I am submitting comments on the Draft Environmental Assessment (EA) for the Quartzville-Middle Santiam (QMS) timber project.

Figure 31: Unit 137 boundaries in Driving Tour packet

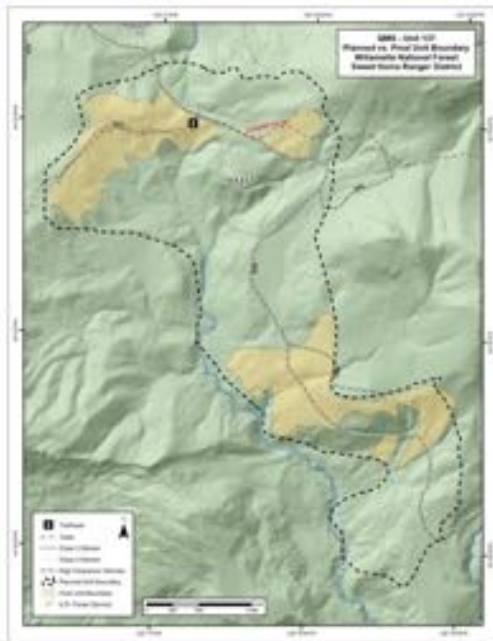
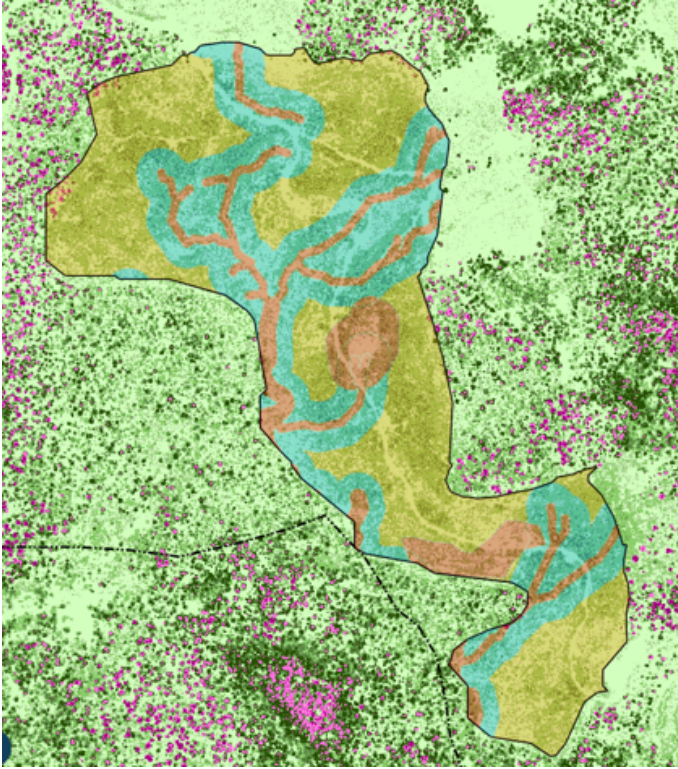
The original unit is unusual because it included many different aged stands, including very large old trees along the northwest edge, in the center and in the southern portion. The QMS Driving Tour included a map of Unit 137 with new boundaries. The new unit boundaries are much better, focusing on the younger denser areas and withdrawing the older tree areas and riparian areas. But since this new map and new treatments are not included in the new EA, I would ask that the draft EA be modified to reflect these new unit boundaries.
